**Re: Huntington Beach Energy Project (12-AFC-02)  
Applicant's Correspondence Related to Air Quality (January and February 2013)**

**APPLICATION FOR CERTIFICATION FOR THE  
HUNTINGTON BEACH ENERGY PROJECT**

**Docket No. 12-AFC-02  
PROOF OF SERVICE  
(Revised 02/19/2013)**

**FIGURE 2.1-3a**  
**Heat Balance**  
 AES Huntington Beach Energy Project  
 Huntington Beach, California

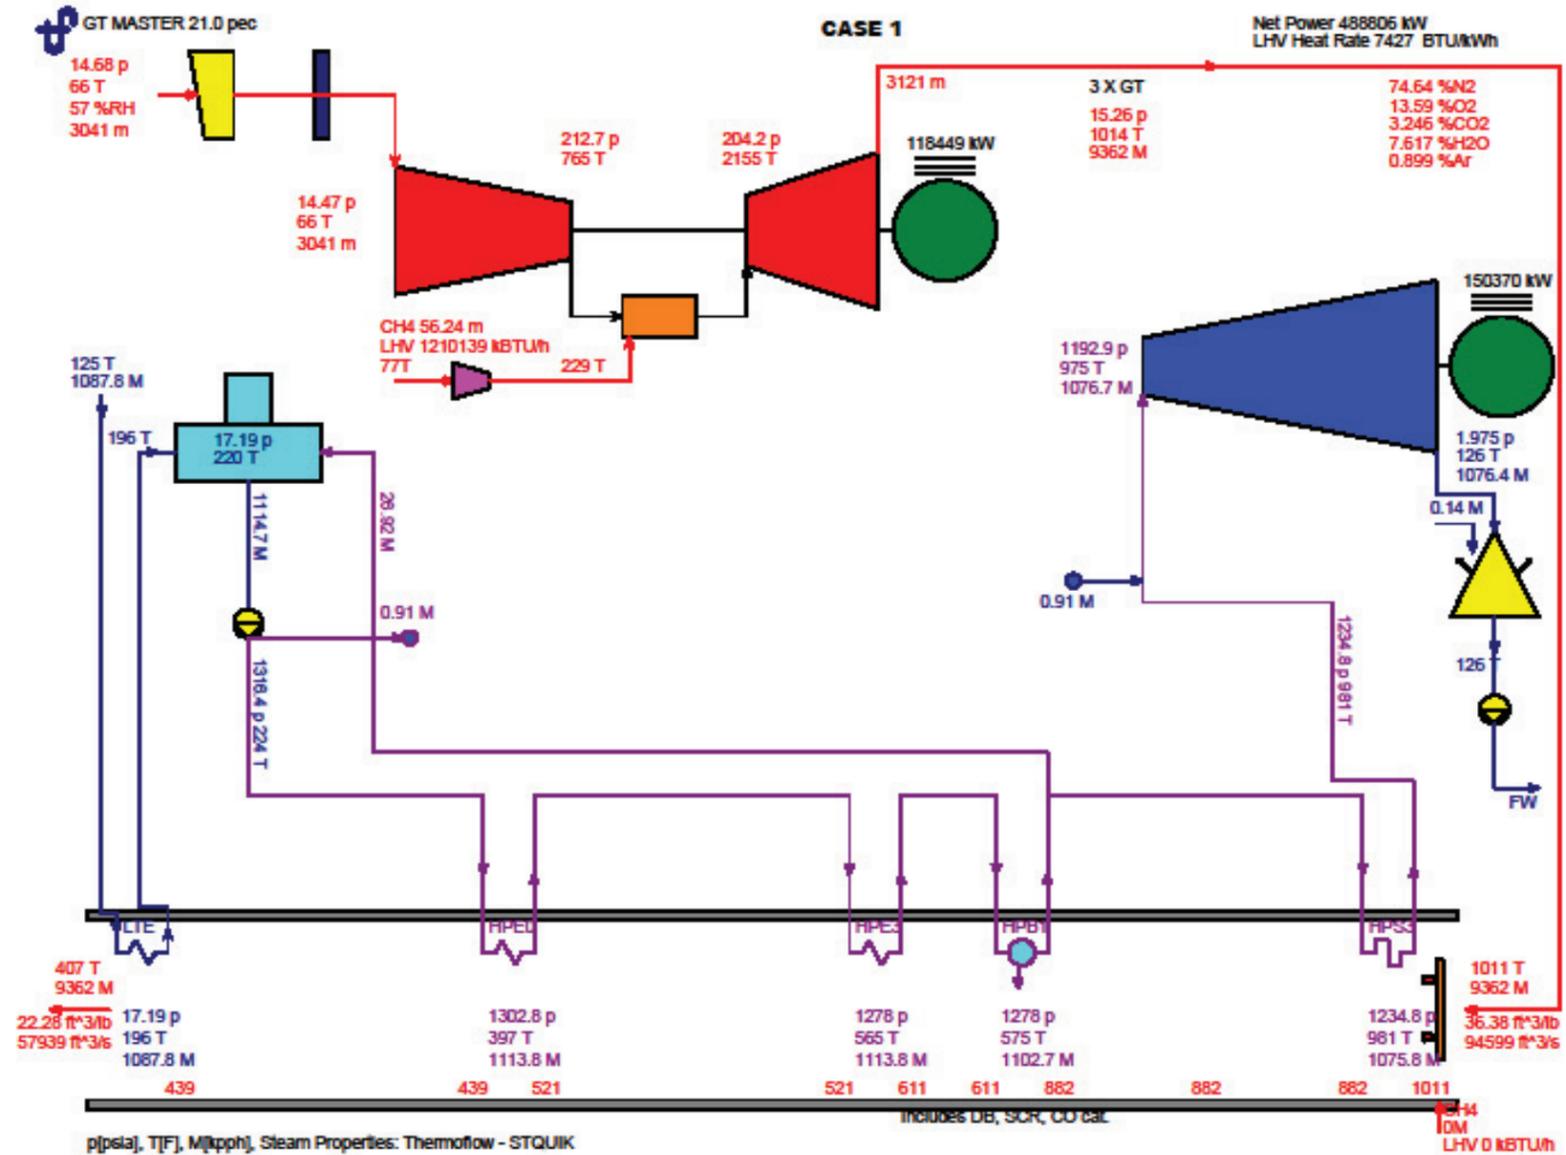
*Can you fill in the following table and provide the detailed calculations? I assume the GHG emission of 3,141,167 tons/year reported in CEC data response DR-12 represents the total CO2E, not just CO2. I still need the data for each GHG, which included in original AFC. Please also indicate the operation scenarios (heat rates, power outputs, etc) to derive the GHG emissions.*

**Response:** Our response to CEC Data Request 12 represented a maximum GHG emission case and assumed that the turbines and duct burner are fired at their maximum rate at an ambient temperature of 32 F, which is not feasible for 5900 hours. Below is a more realistic estimate of the GHG and electrical production based on one of the two power blocks consisting of 3 combustion turbines and 1 steam turbine.

- Turbine hourly heat input (per turbine) = 1210.139 MMBtu/hr LHV or 1331.153 MMBtu/hr HHV (refer to AFC Figure 2.1-3a [included as the attached heat and mass balance Case 1]. HHV to LHV ratio is 1.1)
- Turbine annual heat input (3 turbines) = 1331.153 MMBtu/hr HHV \* 5900 hours/year \* 3 turbines = 23,561,406 MMBtu/year HHV
